30 October 2023

Department of Planning and Environment

## **OBJECTION: CABBAGE TREE ROAD SAND QUARRY – MODIFICATION 3** **State Significant Development Application SSD-6125-Mod 3**

**Identification of a wildlife corridor between the northern and southern sections of the quarry<sup>3</sup>**

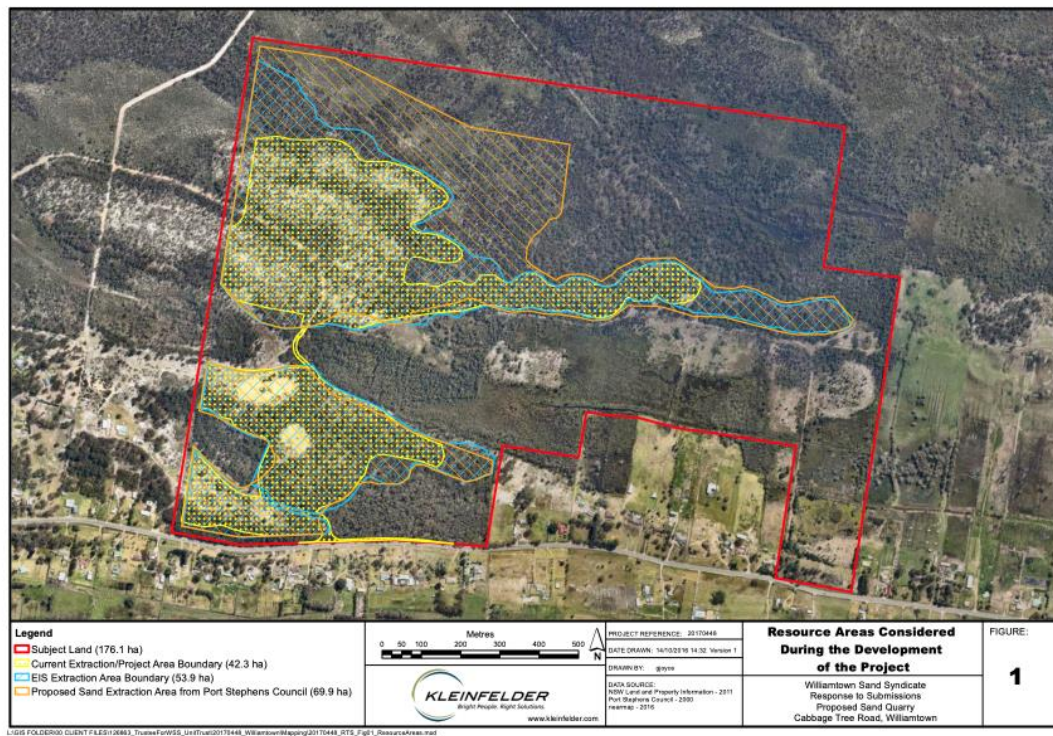
The Proponent now seeks to change the quarry boundaries by expanding into two sections previously removed from the quarry footprint (Mod3 sections 7C-E and 10A-E) and encroaching into a reserved wildlife corridor (Mod3 sections 8A-E and H1-2). As mitigation for biodiversity impact, the Proponent proposes to reserve several small fragments across the original quarry footprint and retire additional biodiversity credits offsite.

The increased clearing for the quarry expansion would break up high quality continuous habitat into smaller fragments, remove an additional 34 hollow bearing trees containing 41 hollows,<sup>6</sup> and increase edge effects across the site. The ecological surveys recorded three threatened fauna in the proposed Mod3 sections, and koalas were assumed present.<sup>7</sup> Nine threatened species were recorded in EIS surveys for the original quarry footprint.<sup>8</sup> One of the Mod3 sections (10A-E) was removed from the original footprint to reduce potential noise and dust impacts to residences near the southern-most extraction areas in response to EPA recommendations.<sup>9</sup> All the proposed Mod3 sections are included in the on-site Biodiversity Stewardship sitea to be conserved in perpetuity under a Biodiversity Stewardship Agreement as part of the project's Biodiversity Offset Strategy (BOS).

The mitigation now being proposed is insufficient: it would not be consistent with key objects of the *Environment Planning and Assessment Act 1979* for an agreed on-site Biodiversity Stewardship site to be largely split in two and further fragmented, and for one of the key connections to other intact forest, the originally reserved wildlife corridor, to be narrowed to a pinch point.<sup>14</sup>

#### Proposed Mod3 expanded extraction areas and sections to be retired<sup>5</sup>

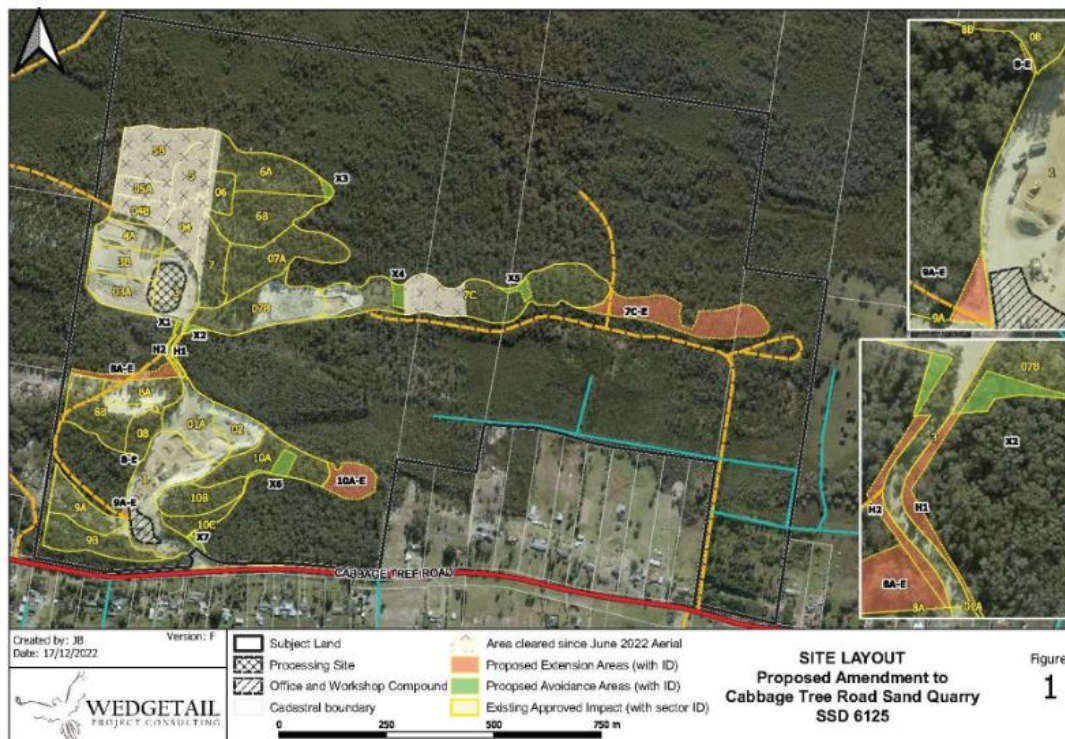
<sup>14</sup> Refer map above. The area proposed to be cleared in the original reserved wildlife corridor (H1, H2 and 8A-E) is 0.44 ha larger than the area to be reserved (X1 and X2). Modification Report No. 3, sec. 4.2, Table 4-2, p 14
